TENASKA[®] BROWNSVILLE PARTNERS, LLC

December 16, 2013

Re: GHG PSD Permit Application Completeness Determination
Tenaska Brownsville Generating Station

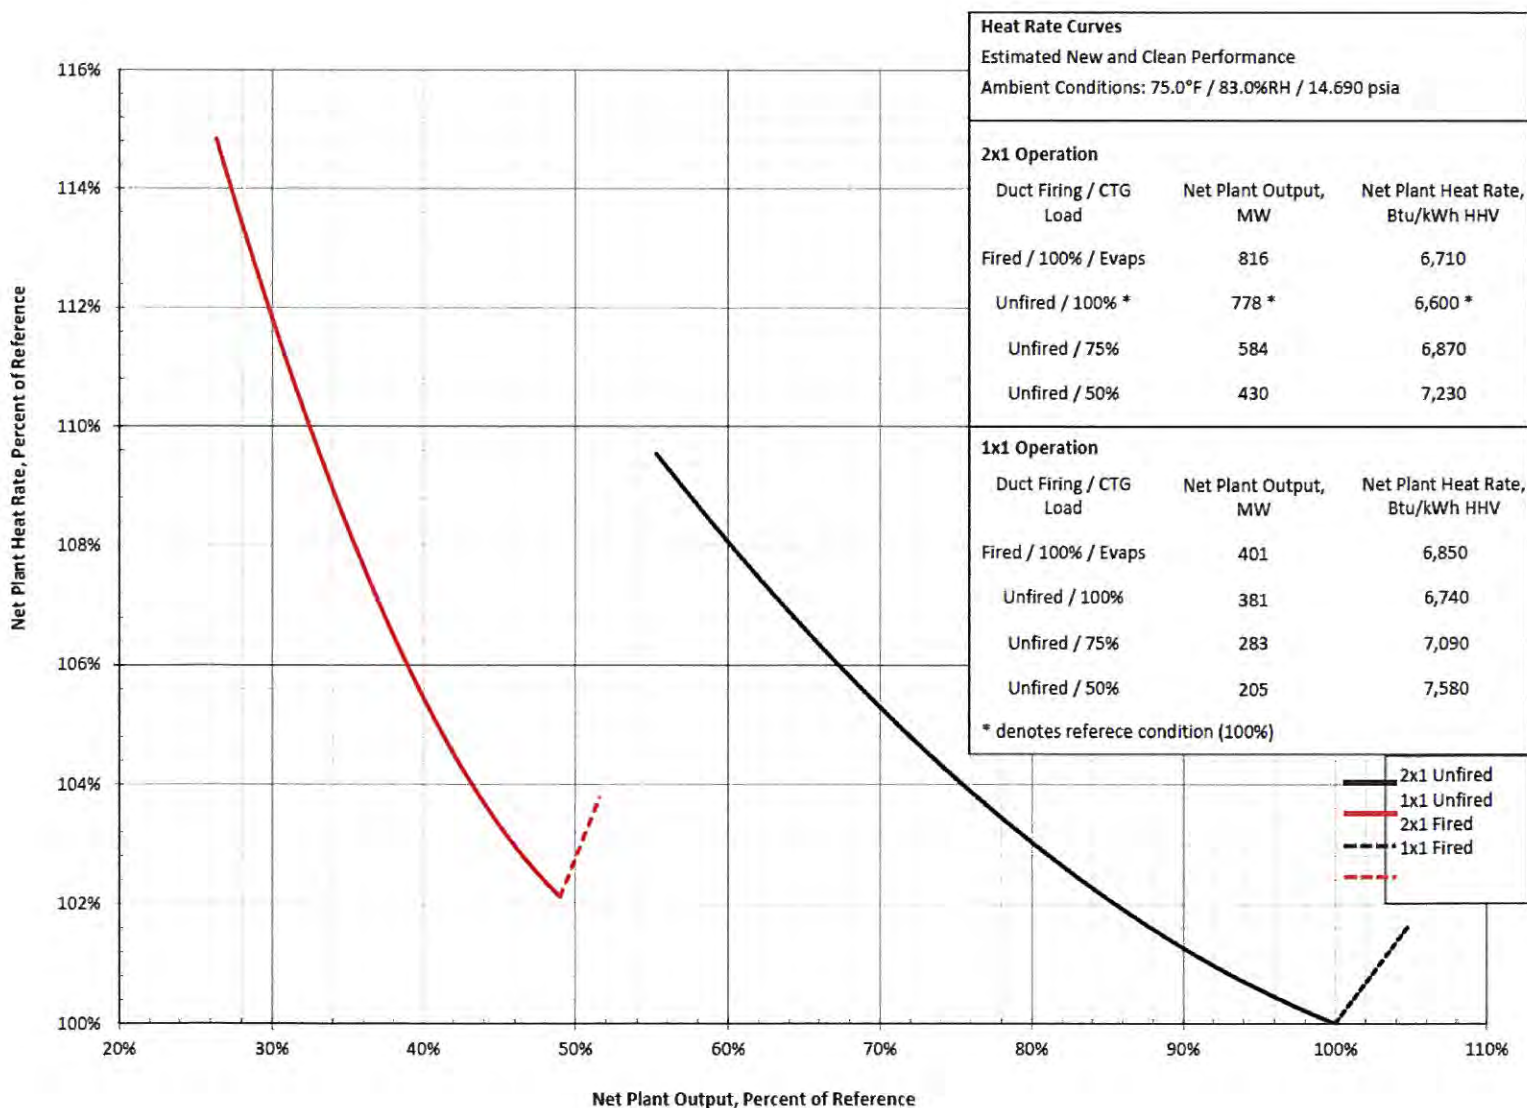
3. Please provide the load efficiency curves for the proposed combustion turbine model.

Please see the “new and clean” plant performance estimates and heat rate curves below.

Combustion Turbine Performance Degradation

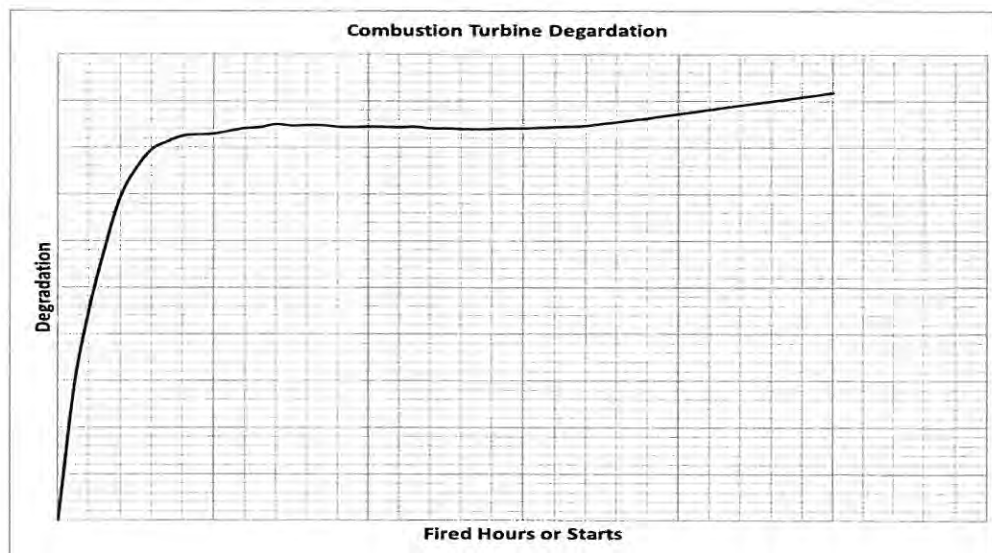
- 4. On page 42 of the permit application the application proposes a 3.3% design margin, a 6% reasonable degradation margin, and a 3% degradation margin for the auxiliary equipment. Please provide a basis and supplemental manufacturer's documentation to substantiate these proposed margins.**

Non-recoverable degradation occurs and continues throughout the operating life of the combustion turbine. As shown below, the trend generally consists of relatively rapid initial heat rate degradation for the first few thousand operating hours/starts which then flattens to a long term degradation rate. The long term impact is a 2.5 to 3.0% increase in heat rate over new and clean performance for the initial major maintenance cycle.
